Juvenile Detention Center Classroom Additions

ADDENDUM #2

ITEM NO. 3. CIVIL SHEET (AD1-DET1) Site Map Clarifications. See attached.

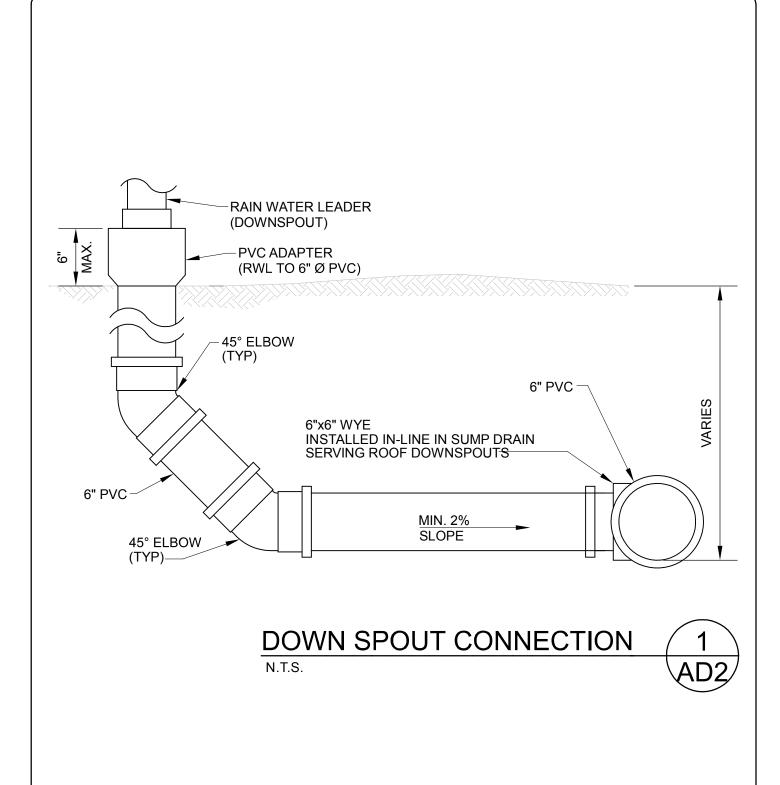
- a. There are four (4) new downspouts at the corners of the new additions. While the northernmost and southernmost downspouts will discharge to the surface, the two (2) westernmost downspouts shall be connected to the new, adjacent 6" PVC storm piping using 6" PVC piping and fittings, including a 6"x6" wye. The adapter from downspout to 6" PVC shall correspond to the attached detail sheet, AD2-DET1.

- b. All lateral extensions from downspouts as shown on sheet C1 shall consist of 6" PVC piping and fittings. In the event that piping is being connected to smaller existing lines (e.g. ~4"), Contractor shall provide the appropriate reducer fittings and ensure inverts are matched to facilitate positive drainage.

- c. All downspout extension piping and subsurface drainage piping designated as PVC on sheet C1 shall consist of SDR26 PVC.
- d. The new curb radius shown at the main entry consists of a 66.6' radius and a 67.1 arc length. The Contractor shall provide a neat, clean saw-cut along this arc prior to installation of the new curb & gutter as shown.

- If, for simplicity, the Contractor wishes to saw-cut and remove sidewalk in a straight line and/or along a control joint instead of saw-cutting along the radius they will be allowed to do so, but there will be no additional compensation for increased sidewalk removal and replacement quantities.

Note: The spot elevations shown near the main entry were interpolated from the topographic

survey and are therefore estimated; these spot elevations are intended only to show the estimated high point of the gutter (i.e., 60.30) so as to ensure proper drainage to the N and S of this point. Contractor shall field verify prior to construction.
